Addendum No. 3
November 29, 2023

Solicitation No. 221 – Request for Qualifications for Professional Architectural Design Services for a New Contemporary Arts Center at City-Brook Community Park
Submittal Deadline 11:00 a.m. CT on December 5, 2023
Recreation and Park Commission for the Parish of East Baton Rouge
BREC Planning & Engineering Department

City Park
PRELIMINARY SCHEMATIC DESIGN PLAN

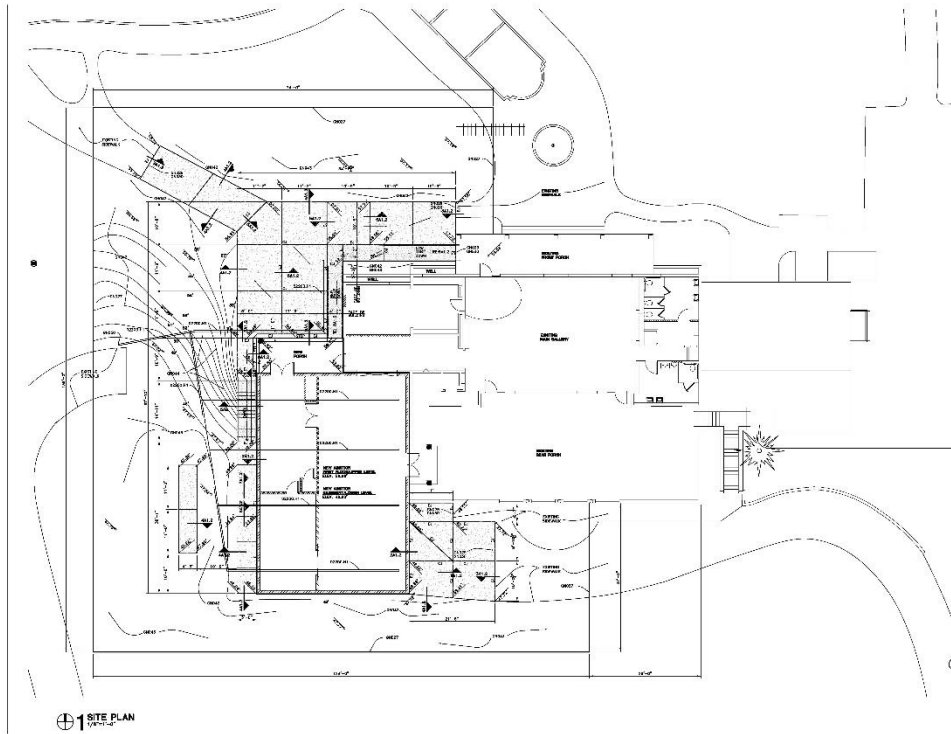
Q56: Is there an existing Master Plan of City-Brooks that we should be aware of?

A56: Yes, see [linked 2006 Master Plan](#).
